LOT 51 - WONGA BEACH DEVELOPMENT

Current Status

Summary of Reponses to Cairns Regional Council's Information Request:

INFORMATION REQUEST - RECONFIGURING A LOT (1 LOT INTO 99 LOTS) VIXIES ROAD, WONGA

Reconfiguration Proposal Plan RPS Revision G Dated: 14th March, 2013

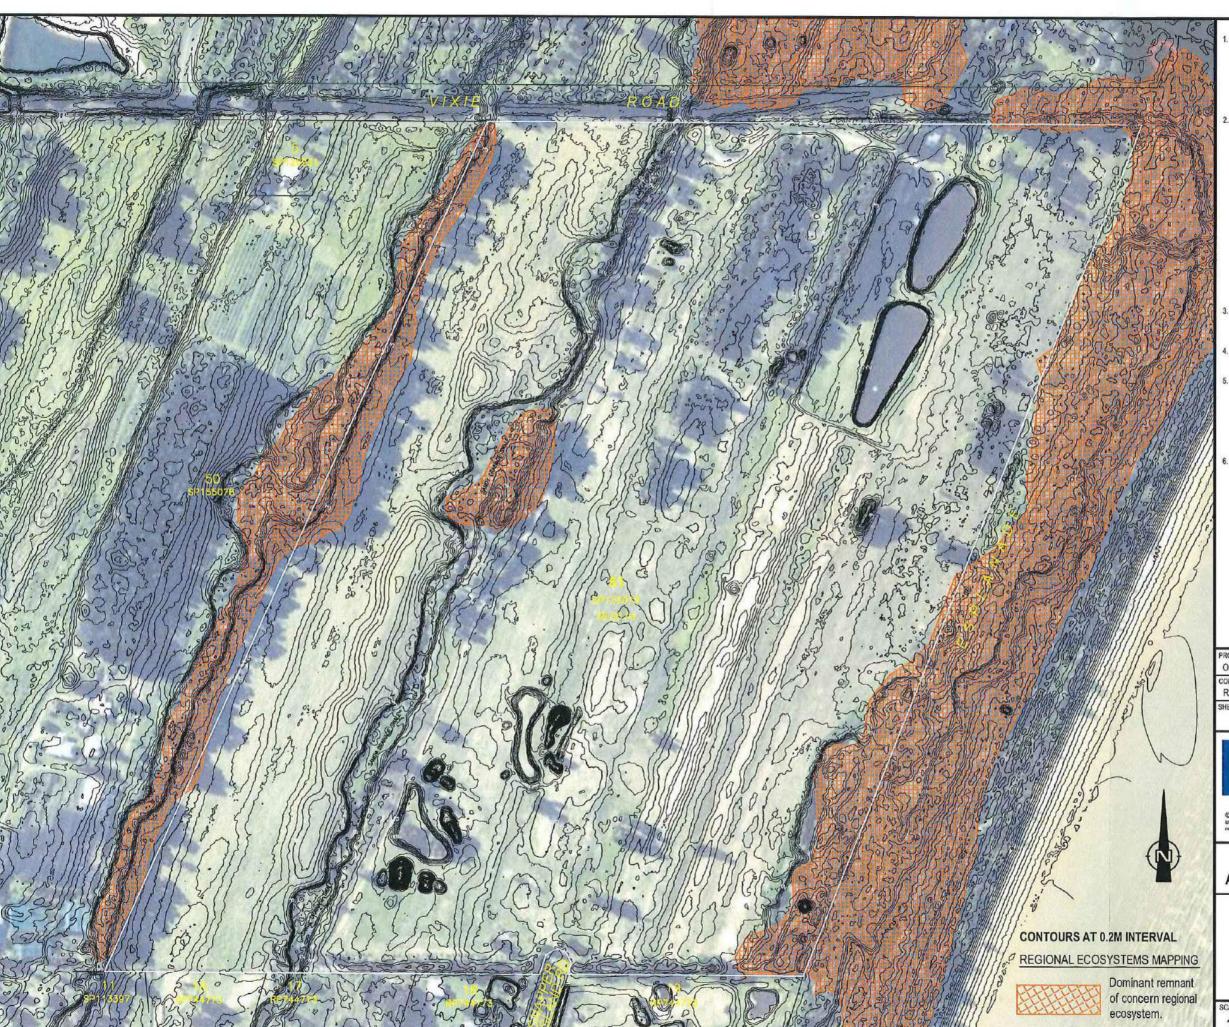
Undertake a review of the development footprint. The layout appears to encroach within the buffer zones and appears to be inconsistent with the representations in other parts of the submission. This includes the representations in the wetland report.

Please note that all wetland buffer areas are to be clear of development including residential lots, road reserves, fill batters, drainage or other associated infrastructure.

- 8. Provide a staging plan in accordance with Condition 9 of the Preliminary Approval.
- 9. Rationalise the layout for Lots 96 99 to provide appropriate road frontage and dimensions consistent with the Preliminary Approval.

An updated Wetlands Assessment Report has been undertaken by Dr Paul Clayton from RPS Australia East. Based on Dr Claytons "Recommendation is that a minimum 20m buffer be applied to Wetland Areas in the Development Site". The reconfiguration Proposal Plan (Appendix B) has been updated to reflect his recommendation.

As addressed in the Reconfiguration Proposal Plan (Appendix B).
